HARRAH'S NOLA CIP **AREA E RESTROOMS (120)**

BULLETIN 120-03 10/12/2022

ENLARGED PLUMBING PLANS - FOH RESTROOMS

120-P-420

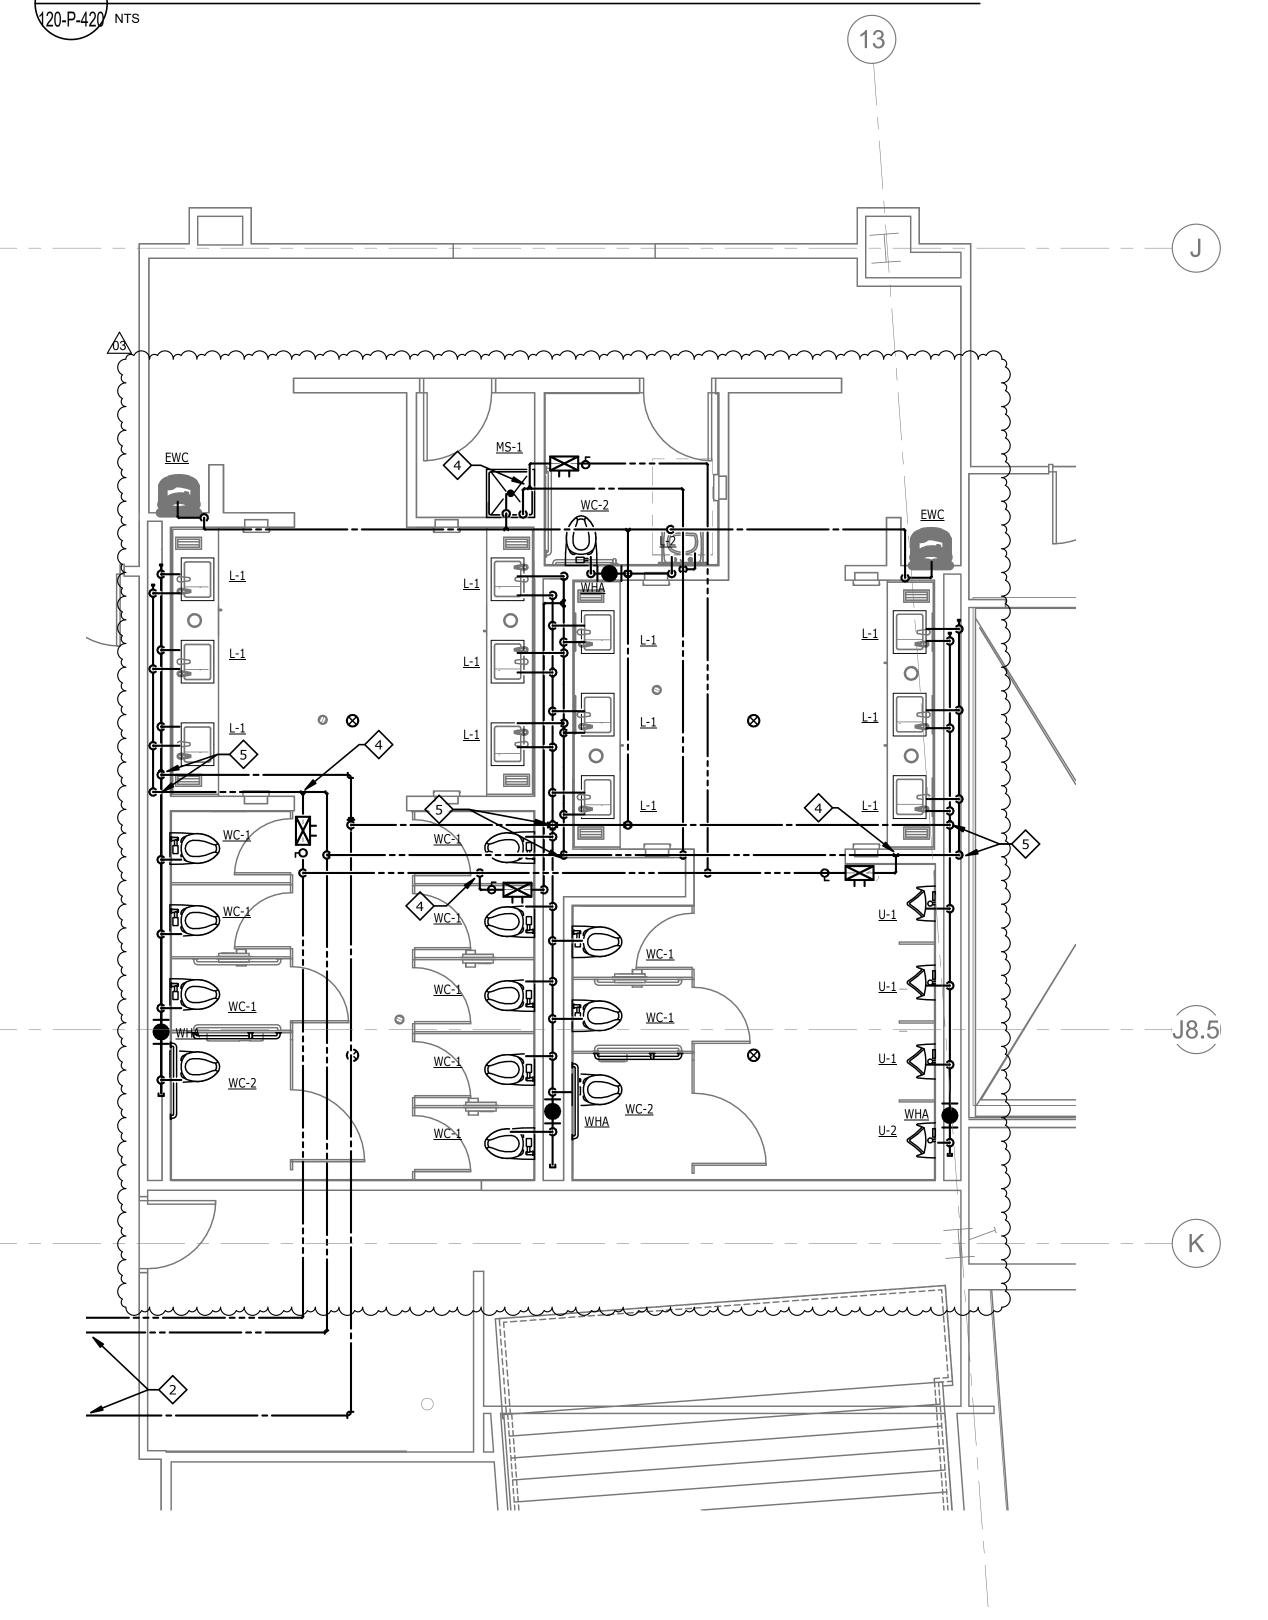
REVISED ENTIRE SHEET
